PROJECT: A-cab

| <b>SUBJECT:</b>                                                       | Drainage Study for:                  |                                                                                                   |
|                                                                       | <b>A-Cab</b>                         |                                                                                                   |

**ADDENDUM #1 TO  
UPDATE #1 TO THE TECHNICAL DRAINAGE STUDY  
FOR  
A-CAB TAXI FACILITY  
(APN# 139-26-201-004)**

**FIGURE 4**

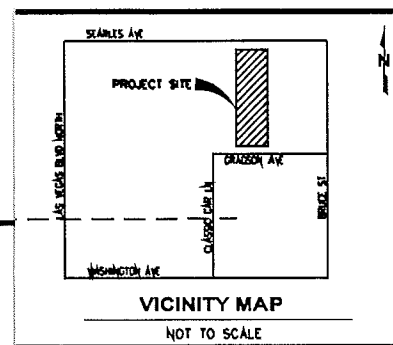
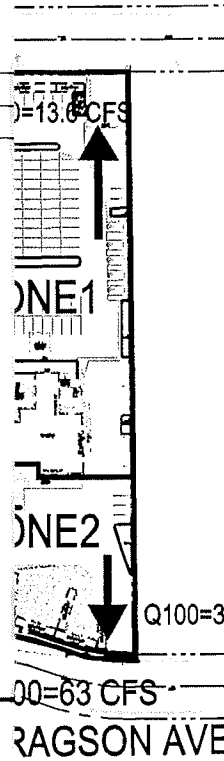
COMMENT#2: The notion of 10% split of the Q100 = 70cfs from Basin B1 into Basin B2 had not been clearly demonstrated in the subject drainage study. The flow split should be done in a few methods to support the final conclusion. Calculations such as weir flow and the Pima County split flow method are acceptable.

It appears that more survey shots / street grades are needed in Gragson Avenue upstream of the subject site to verify the location and width of the proposed weir for the split flow.

RESPONSE#2: The Pima County split flow method was used and the calculations are included in this addendum. The calculations show that there is 7 cfs coming from Basin B2 with 63 cfs continuing down Gragson Avenue. Figure 4 has been revised to reflect the new flows along with the depth of flow calculations associated. Additional survey shots were taken as suggested.

# DRAINAGE EASEMENT

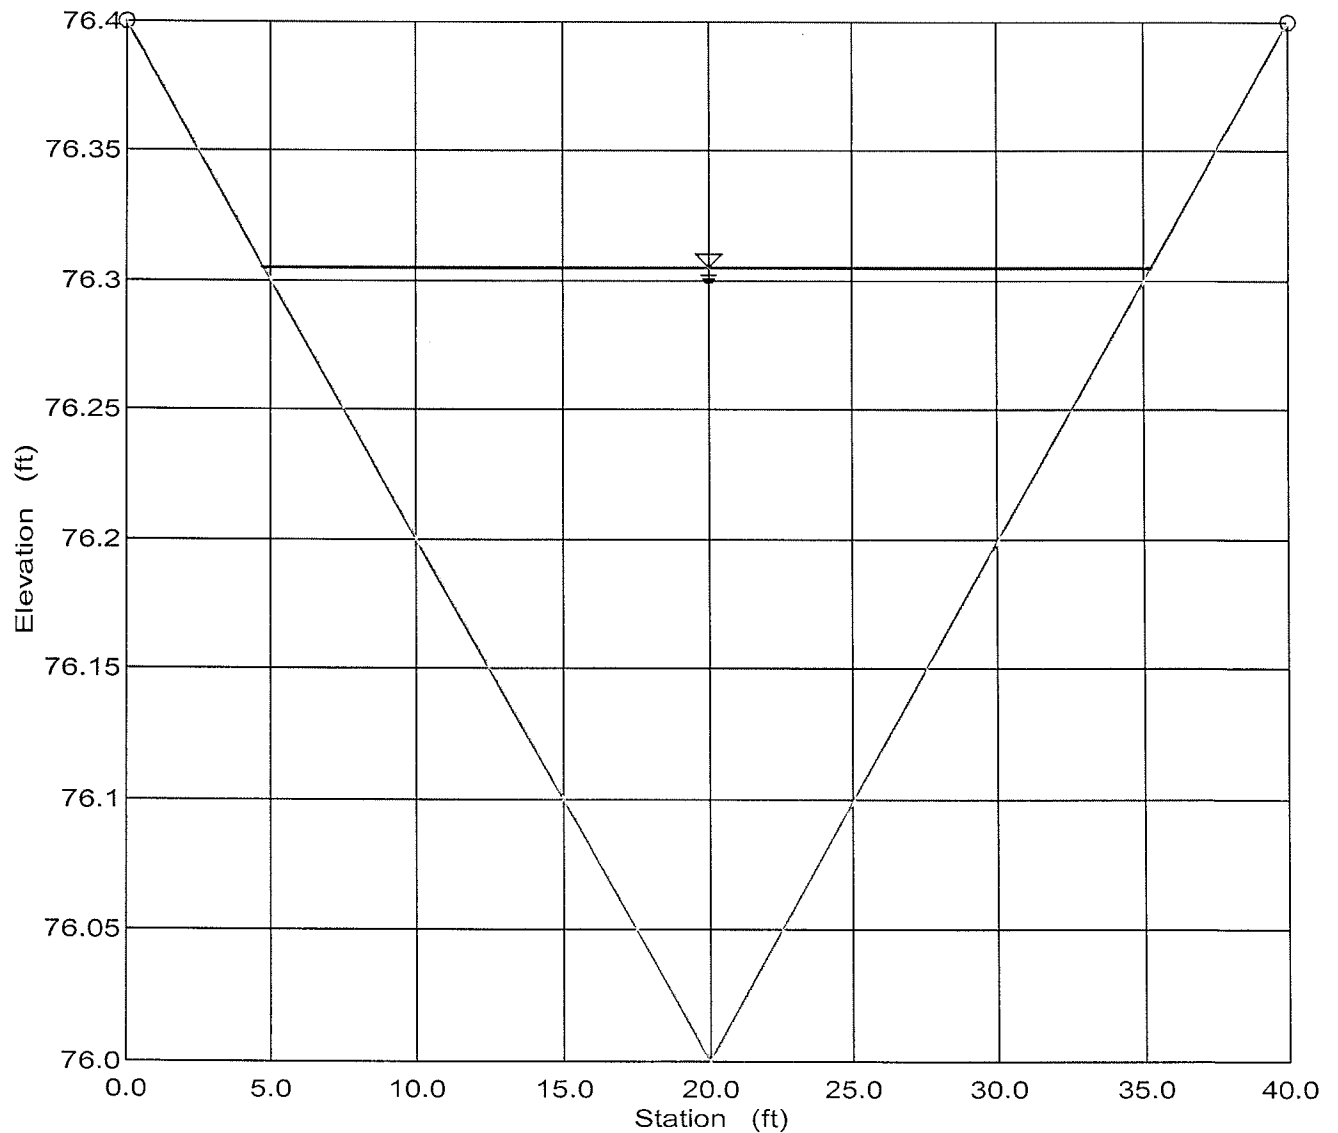
COMMENT#5: The slope in the proposed drainage easement indicates very flat conveyance, ie, less than 1%. Provide a 2'-wide concrete valley gutter within the drainage easement. Provide hydraulic calculation to verify that the total width of the drainage easement contains the 100-year flow.

RESPONSE#5: The FlowMaster calculation for the onsite drainage easement used a channel slope of 1% which as stated in Comment #4 is not correct. The actual slope in the drainage easement ranges from 0.25% to 0.8%. Review and re-calculate accordingly.

COMMENT#6: The depth of flow using FlowMaster was revised accordingly and the width of the drainage easement was increased to 30-feet to assure the 100-year flows are contained inside the easement.

**GPI.0**

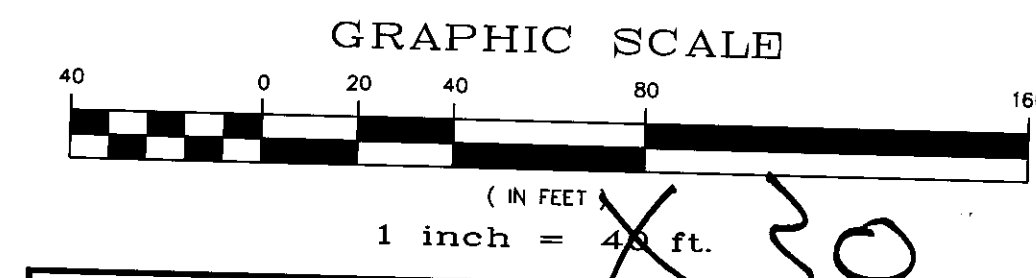
COMMENT#3: The proposed 20' – drainage easement must be labeled as “Public Drainage Easement to the Privately Maintained” on the grading plan and to be granted as such by separate document prior to the final approval of the drainage study.

COMMENT#4: The slope in the proposed drainage easement indicates very flat conveyance, ie, less than 1%. Provide a 2'-wide concrete valley gutter within the drainage easement. Provide hydraulic calculation to verify that the total width of the drainage easement contains the 100-year flow.

RESPONSE#3: The drainage easement was relabeled as requested.

RESPONSE#4: A 2-foot valley gutter has been added in the flow line of the drainage easement.
